WORONORA RESERVOIR IMPACT STRATEGY

- STAGE 2 REPORT

Metropolitan Coal Longwall mining near and beneath Woronora Reservoir

June 2019

Figure 4.1 “Height of Fracturing” concept.⁷

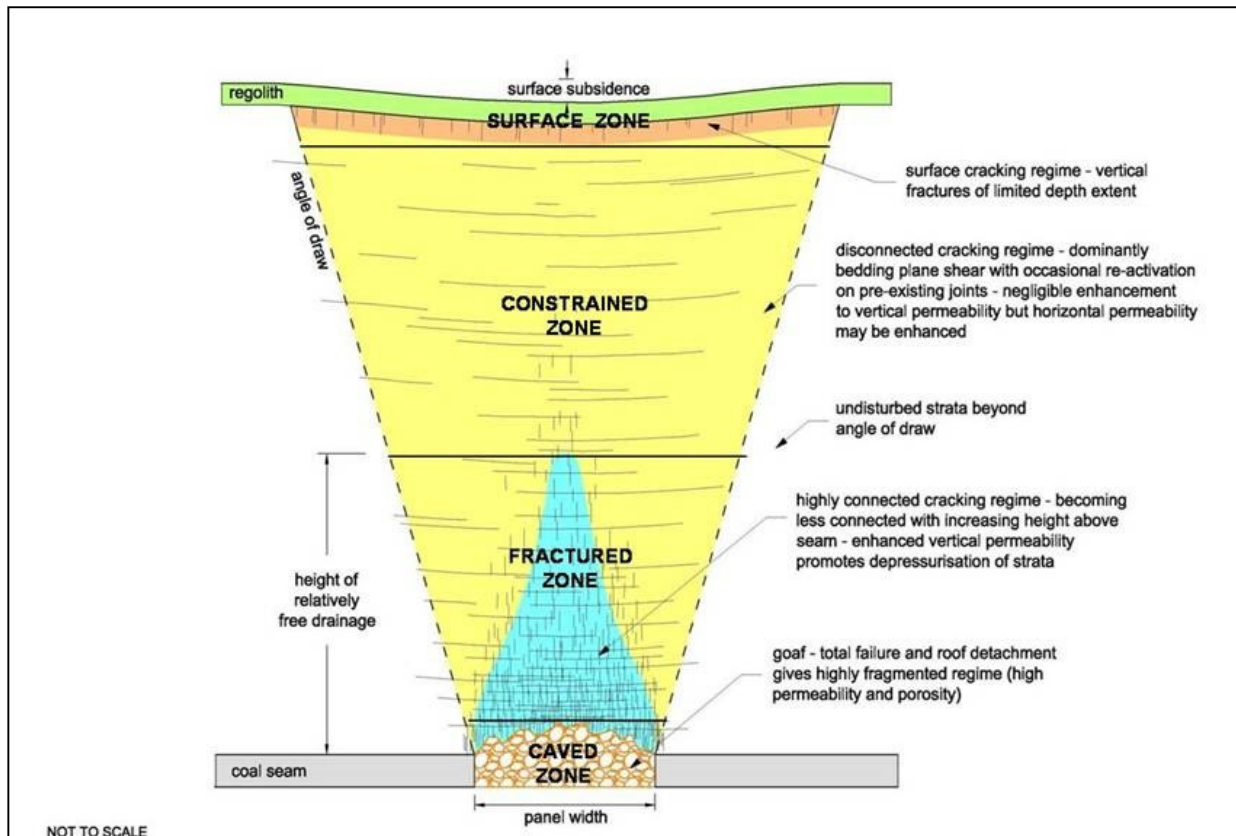
⁷ While Figure 4.1 displays the commonly quoted main four zones that can often occur in the geological profile above longwall mining panels, some features shown are not necessarily correct. This includes the horizontal line across the figure labelled as the ‘height of relatively free drainage’ and the inverted “wine glass” “fracture zone” coloured blue. The height of “free drainage” maybe quite irregular and it may not necessarily occur on either of the far sides of the fracture zone peak as suggested by the horizontal line. Also the “fracture zone” most often has an inverted parabolic shape. It should be noted that there is also a six zone configuration proposed by Mills (2012), as was referenced in the Stage 1 report.

Figure 5.3 Pressure head graphs prior to, during and post longwall mining 302GW01

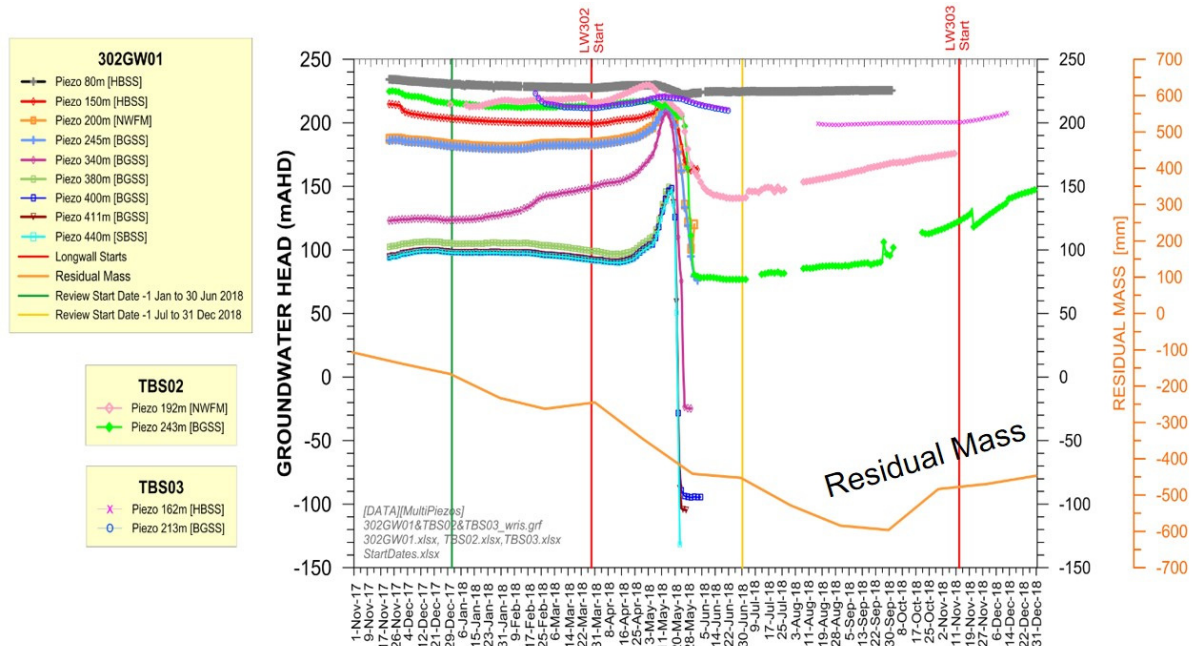
Figure 5.3 indicates a number of deeper VWP's that display a slow rise over a couple of weeks in pressure followed by a relatively sudden rise within several days or so in pressure levels, followed in turn by a substantial decline of the pressure head as the longwall mining passes these piezometers. The slow initial rise seems likely due to mining of LW301. The probable cause for the main sudden rise in pressure is that it is due to compression effects of fine grained, low permeability strata. This effect has been noted in other environments in the literature. Further detail on this phenomena is provided in Appendix A herein. In summary an initial temporary rise rather than a pressure decrease (i.e. substantial pressure decline) is thought to be caused in the relevant piezometer by poro-elastic effects, that is by compression of low permeable and fine-grained layers (possibly by claystone strata within the Stanwell Park Claystone unit in particular) but also by other such low permeable layers present in the geological profile close to the caved zone. It is relevant for example that the Bulgo Sandstone Formation is comprised of layers of fine to medium-grained quartz lithic sandstone with lenticular shale interbeds.

Less pressure effect is evident in piezometers with increasing height above the caved zone as the longwall panel is removed. There is very little rise effect at 150m depth and virtually almost none at 80m below ground surface (bore 302GW01 in Figure 5.3). According to Hydrosimulations (2019) pressure pulses at bore F6GW4 (located between longwalls 303 and 304) display "*cusps-like features on the Hawkesbury Sandstone*", and "*sustained rises in the upper to middle Bulgo Sandstone*".

The pressure levels that show major pressure decline are the deeper fibre optic piezometers (2 to 4) and VWP01 as longwall 302 was mined. Following the sharp decline in pressure head as shown in Figure 5.3 three shallower piezometers have displayed some pressure head recovery. The rainfall residual mass curve for this period indicates that the head recovery is not due to rainfall recharge. Recovery of pressure head following the passing of an excavated longwall panel is not unusual and recorded in the literature at a number of mining sites. It is quite possible this is due to migration of higher surrounding pressure head in the profile to lower pressure head zones.

However, the question arises whether it is possible to analyse the pressure declines observed in Figure 5.3 to determine the state of connective fracture network developed in the geological profile. While this is not entirely straightforward the following is a possible result of such analysis. Connective fracturing would induce desaturation and possible complete or ongoing draining of groundwater immediately above the extracted seam. Hence by selecting those piezometers that displayed substantial decline of pressure head, the extent of possible connective fracturing was determined. For assessment the piezometers with openings at depths of 440m, 411m 400m and 340m that show substantial pressure head decline were selected. Adopting the depth of the extracted Bulli seam at a depth of 535m (based on MSEC seam contours)⁸, then 535m – 340m = 195m. That is, the possibility exists that substantial to significant fracturing extends up to 195m above the Bulli extracted seam.

Figure 6.5 Measured hydrographs at flow monitoring stations I and K and observed rainfall at station PV8

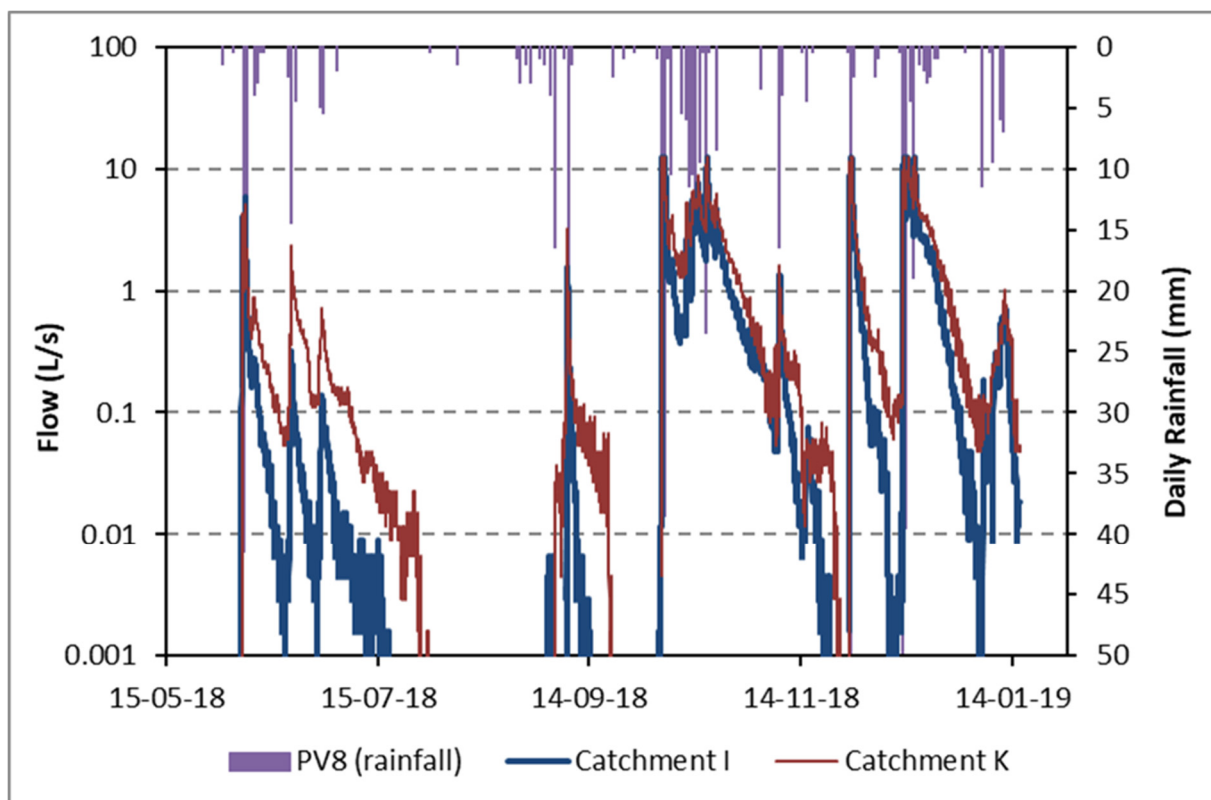
The Panel concurs with this summary observation and recommends a further analysis of the recessions that cover at least the initial 12-month period.
